172 Central Ave
Subject Property
Built 1883
“Italianate”
Level 1

Re: Structural Review
Private Residence at 172 Central Avenue
Our file No. 18-15-0142

Unsafe Building – Order to Make Safe

RE: 172 Central Ave Site Inspection

Image 1: West side of exterior wall at main entrance.
(Image shows window at grade; Gas Meter Location, Entrance patio framing.)

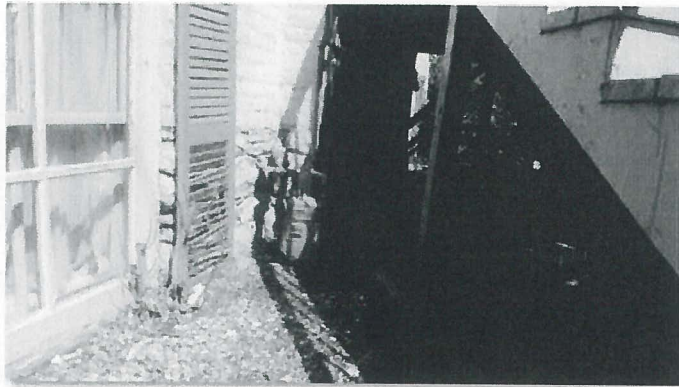
Gas meter; A gas meter is located adjacent to a basement window while also under the front entrance patio. By today's code requirements, this location is unacceptable and the meter is to be relocated.

Basement windows; Throughout the building, basement windows were at grade level. No window wells are installed. Water stains on the foundation walls in the basement and rotting of window frames was

Front Entrance; The exterior stair and patio accessing the front entrance is constructed from conventional wood framing. Wood posts were placed on grade without proper foundations.

observed. In this circumstance, window wells are to be provided or adjustments are to be made to the exterior grade.

Image 3: Penetration in Exterior Brick Wall

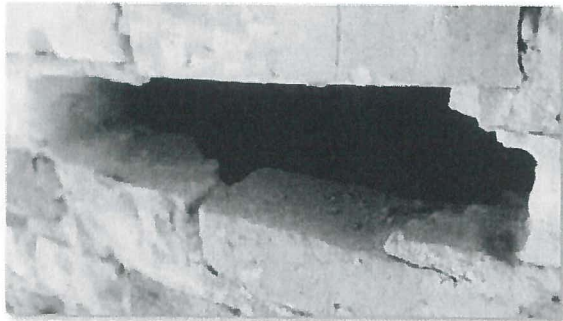
Exterior Brick: The exterior brick Wythe appeared to be non-load bearing. Penetrations in the brick at floor joist locations showed the interior structural framing is supported by the interior Wythe of brick only. The two brick walls were tied together using clay bricks headers. The spacing of the headers was not determined at the time of the review.

Image 7: Rear Brick wall

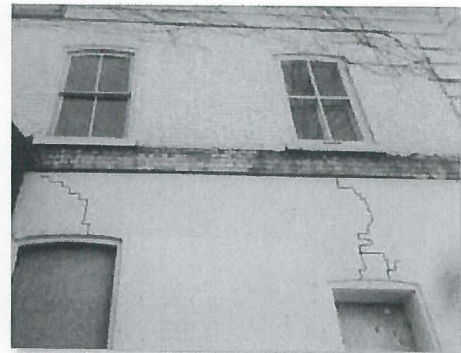
Cracks in the exterior brick were observed at many location including most window and door opening. The cracking was predominantly within the mortar joints however, where windows were stacked between the main floor and second floor, cracks were seen to pass through several bricks. At the rear of the house, cracks in the brick extended from the foundation up to the eave.

A bow in the exterior brick could be seen along the east wall at the second floor elevation. Cracking in the brick has been highlighted in the images below for clarity.

Image 8: Exposed wood framing
And Window at grade. (At Rear)

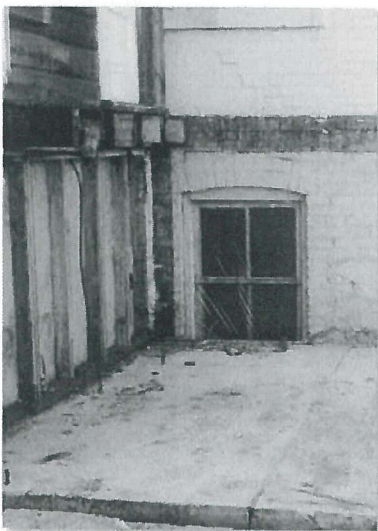
Rear Addition; At the rear of the residence, a small wood framed addition is installed. Portions of a stud wall supporting the addition, with wood floor joists and wood paneling. Along the north end, the wood framing is exposed to the environment. Rotting and damage to the wood structure was observed including warping of the supporting stud wall.

Image 14: Stud and Header framing of load bearing wall
Near main entrance.

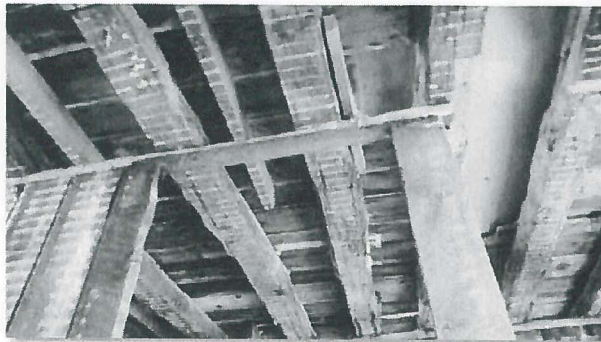
Stud Framing; Stud and headers within interior bearing walls at the front of the house were installed on their flats. At some location, headers and top plate were missing. The stud framing was offset of supporting beams and load bearing wall below. Reworking of the stud framing is required with installation of proper headers to support the floor framing above.

Image 16: Connection of Double Cantilever Joists

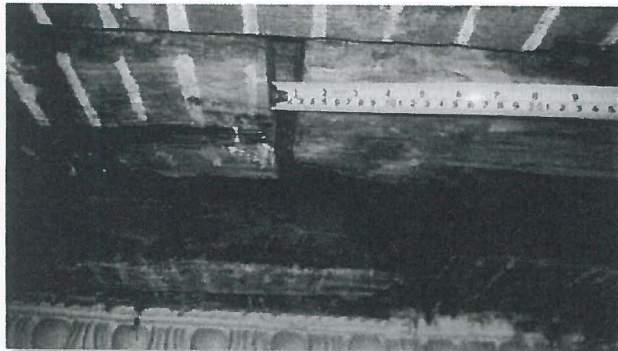
Floor framing; The wood framing supporting the second floor consists of two styles of framing. At the rear of the residence, timber joist spanning between exterior brick walls was used. At the front of the house, a non-conventional double cantilever system was used. The components are friction fit, no wood dowels were observed. The bearing walls on the main floor were offset of the brick walls below.

Image 18: Longitudinal Crack in wood joist

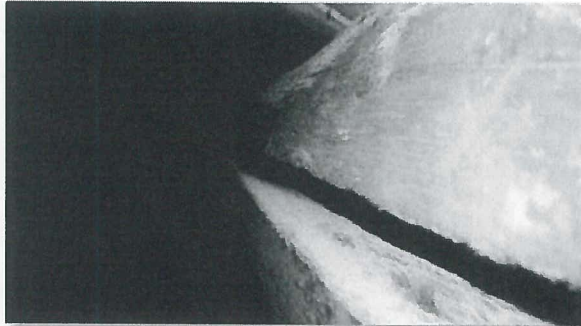
Throughout the second floor framing, several floor joists had longitudinal cracks, in some cases exceeding 1" in width. Joists throughout were seen to be cut, damaged, rotted, charred and in some location with minimal joist depth at bearing points. Spaces between friction joints have developed as the building settles. The current state of the framing requires repair or replacement. Rotting of wood joists were confirmed by drill testing and are not suitable to support the floor loading.

Image 24: Joist framing on brick Wall.
Joist are cut and charred.

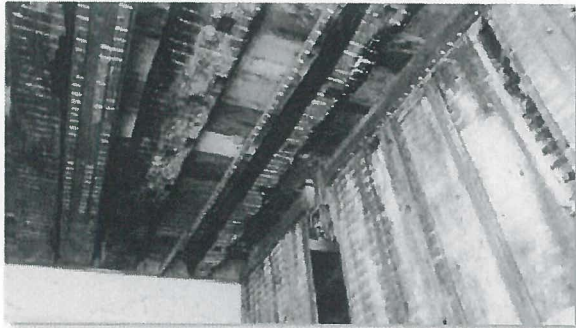
Perimeter Brick Wythe. The existing brick walls consist of two wythe of brick separated and air gap and the floor joist bear solely on the interior wythe. Based on the joist spans and floor loading, the single wythe of brick is overloaded. Cracks and bowing the interior was observed. Additional support of the floor joists is required.

Image 30: Cracking at Window

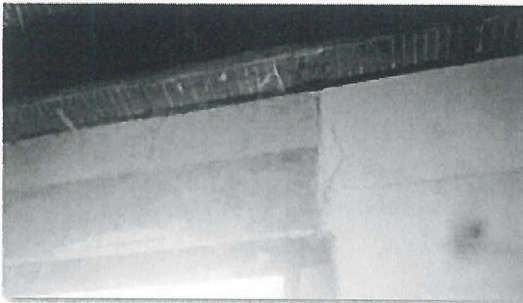
Interior Brick Wythe and Window framing; Brick framing is installed as prescribed previously. Cracking of the plaster and brick wall at the corner of windows was observed. Further investigation determined that wood lintels over windows are damaged due to moisture and a bow in the east brick wall was observed.

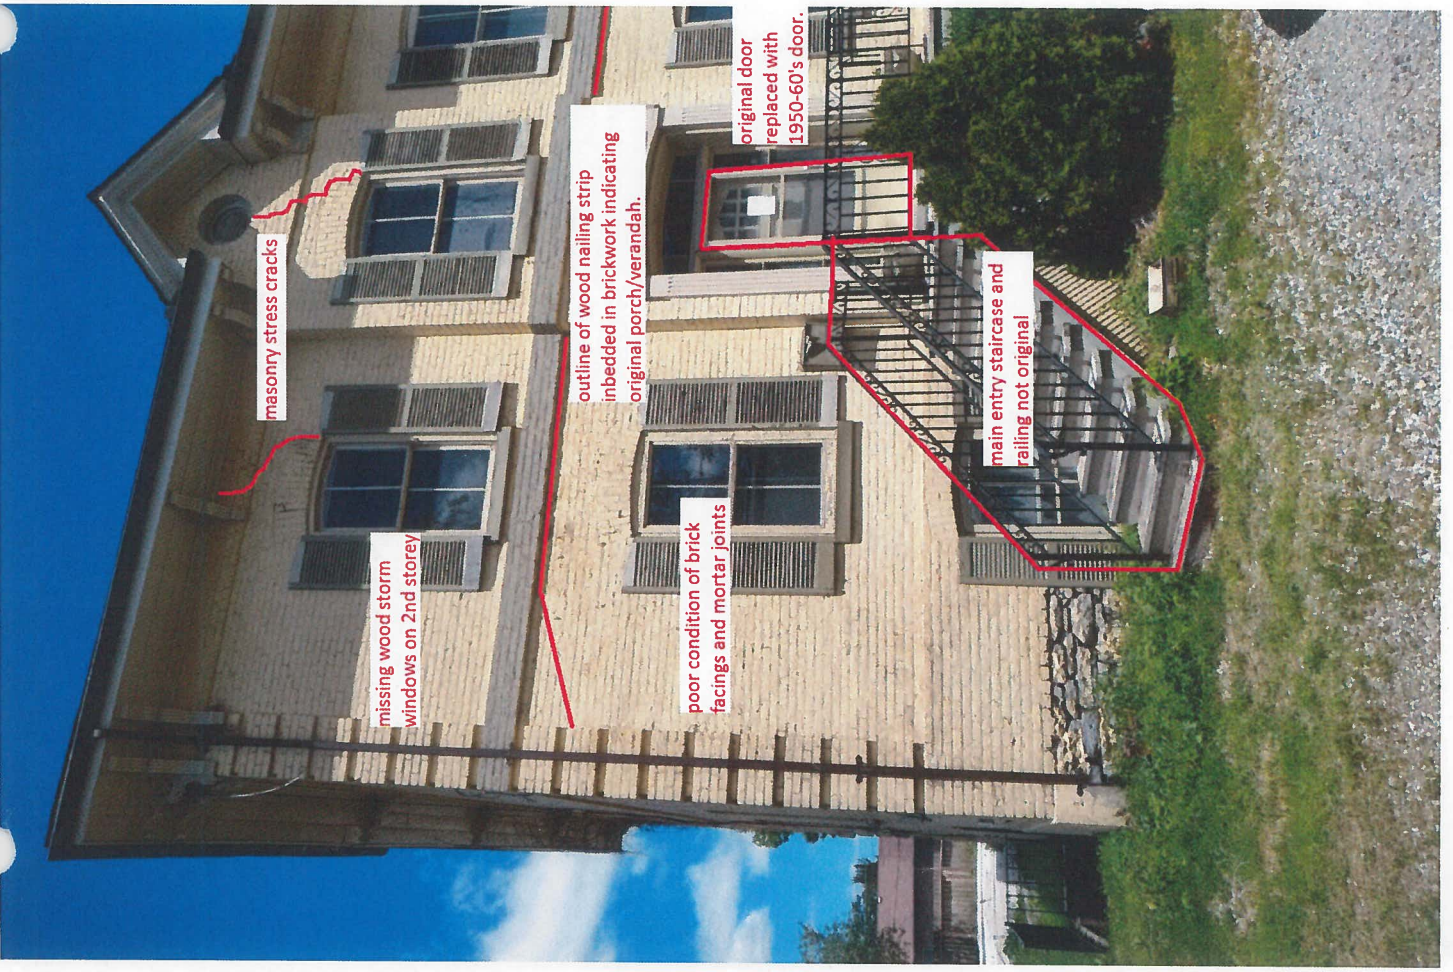
masonry stress cracks

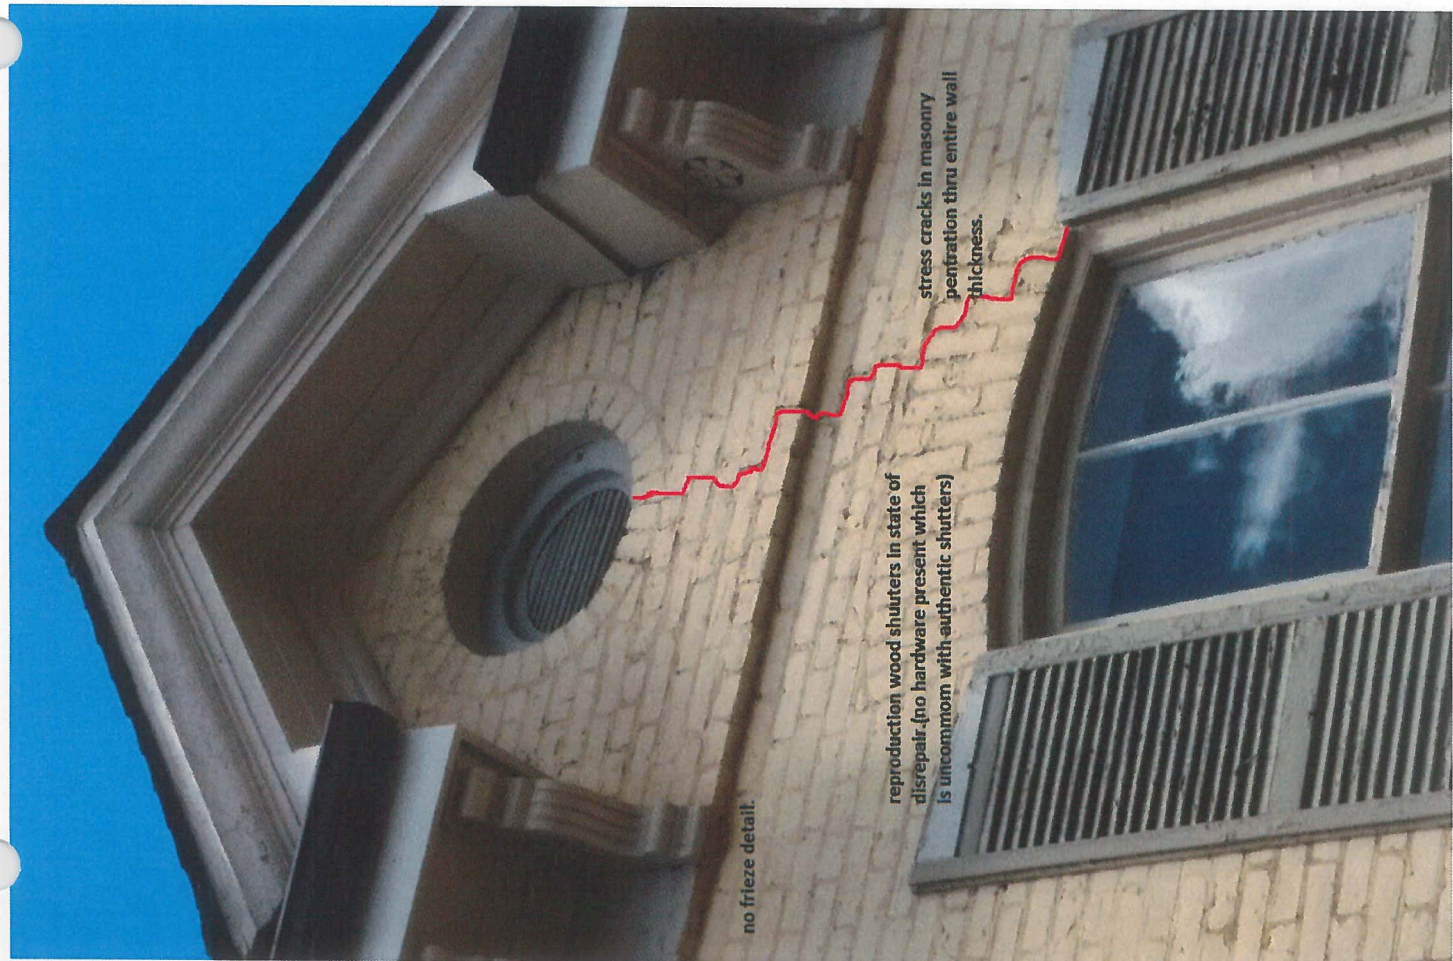
missing wood storm windows on 2nd storey

poor condition of brick facings and mortar joints

outline of wood nailing strip imbedded in brickwork indicating original porch/verandah.

original door replaced with 1950-60's door.

main entry staircase and railing not original

no frieze detail.

reproduction wood shutters in state of
disrepair. (no hardware present which
is uncommon with authentic shutters)

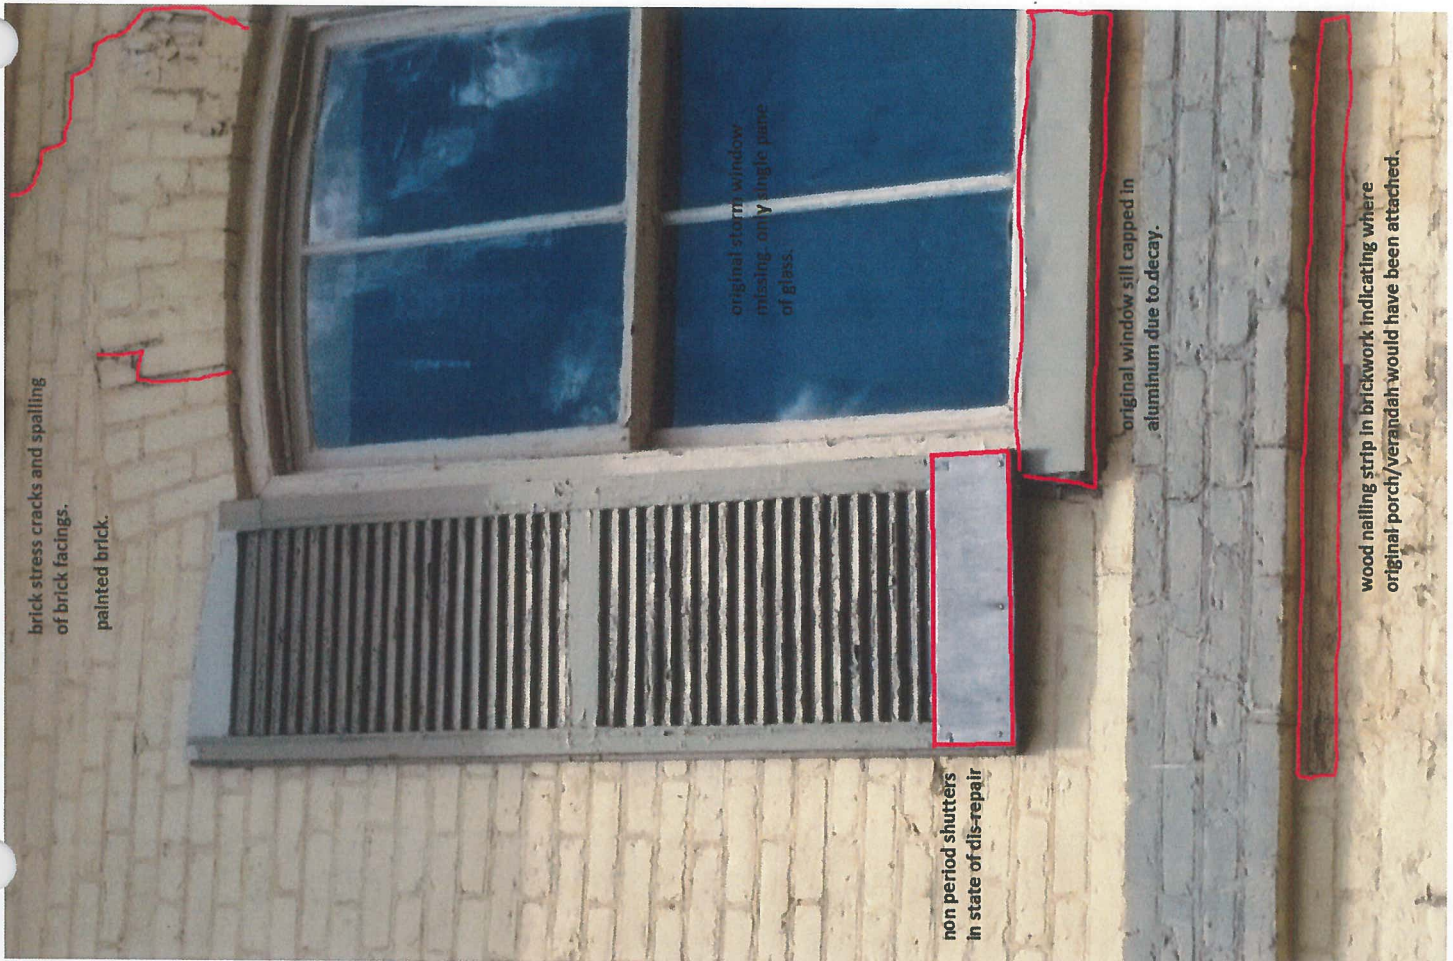
stress cracks in masonry
penetration thru entire wall
thickness.

brick stress cracks and spalling
of brick facings.
painted brick.

original storm window
missing only single pane
of glass.

non period shutters
in state of dis-repair

original window sill capped in
aluminum due to decay.

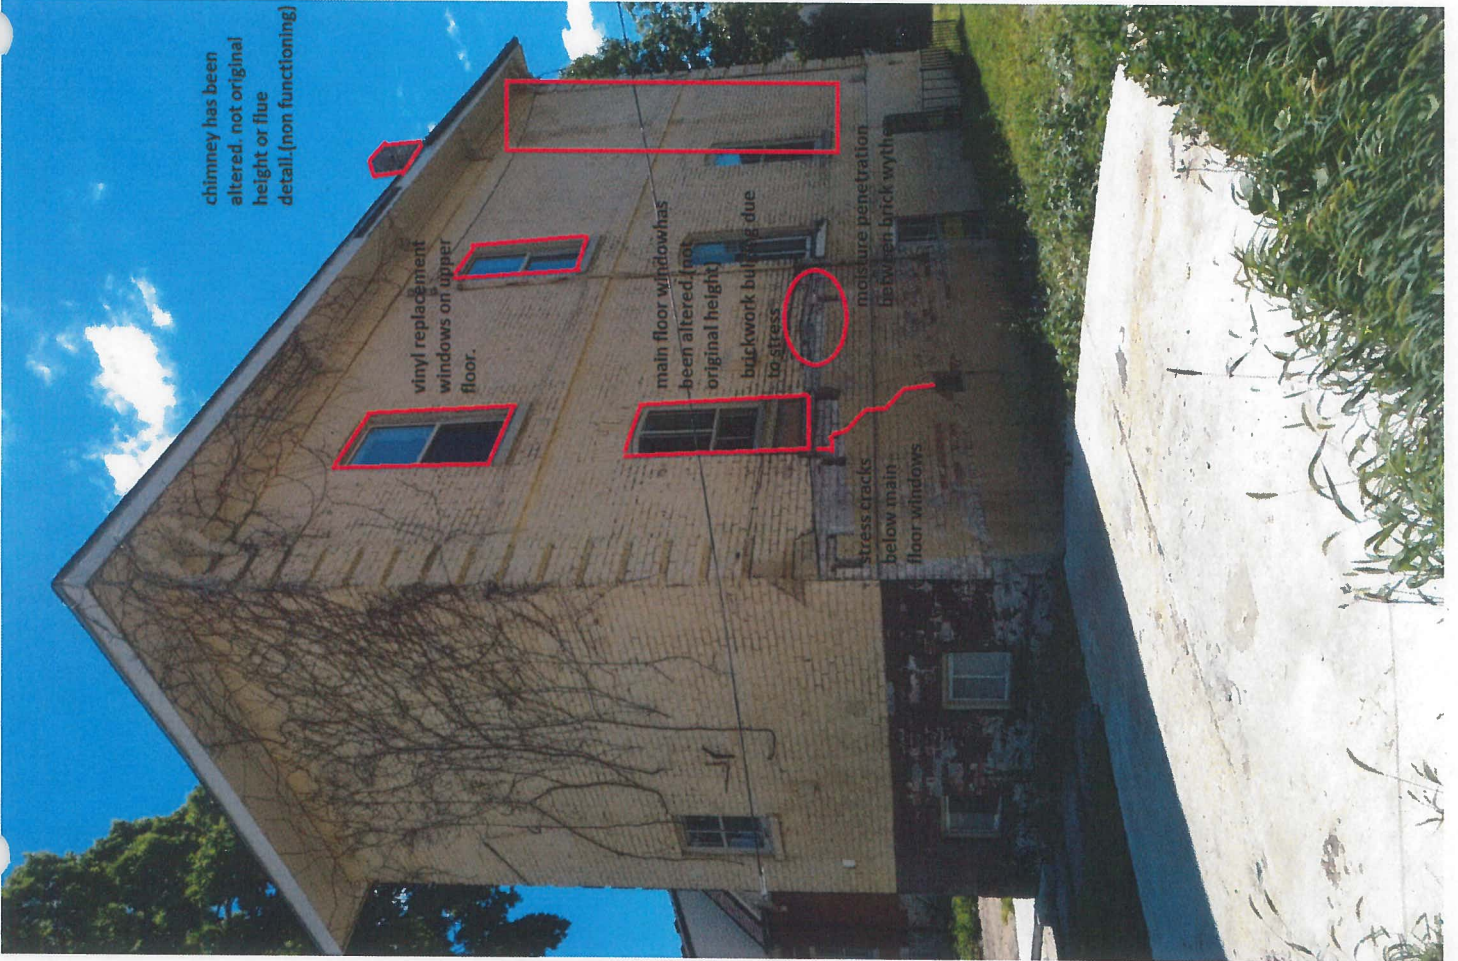
wood nailing strip in brickwork indicating where
original porch/verandah would have been attached.

chimney has been altered. not original height or flue detail. (non functioning)

vinyl replacement windows on upper floor.

main floor windows have been altered. (not original height) backwork building due to stress

stress cracks below main floor windows

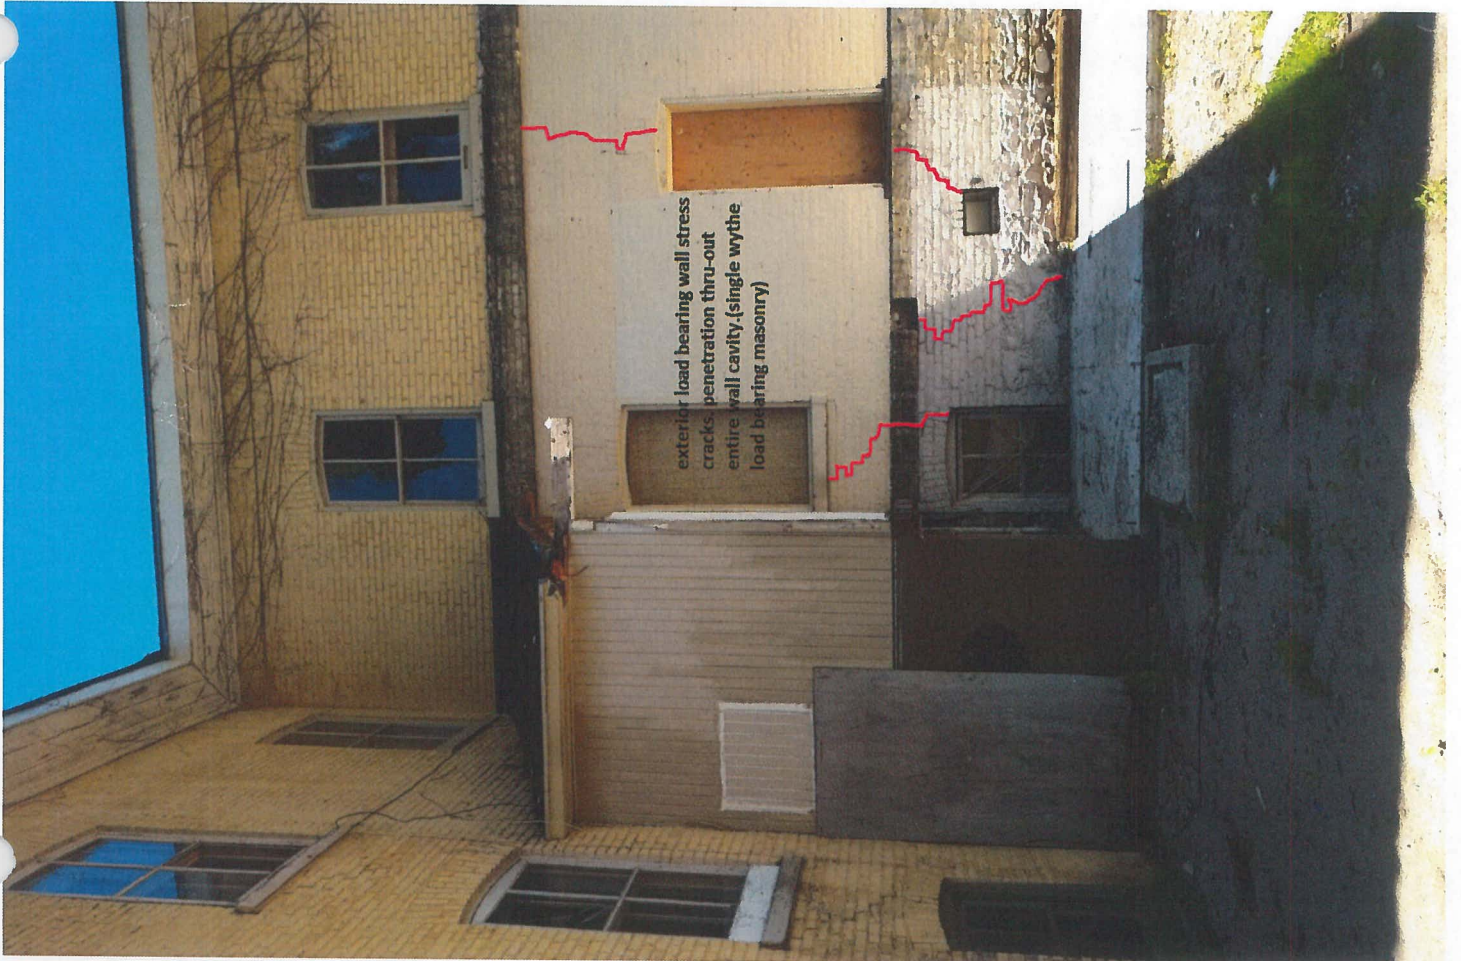
moisture penetration below brick wythe
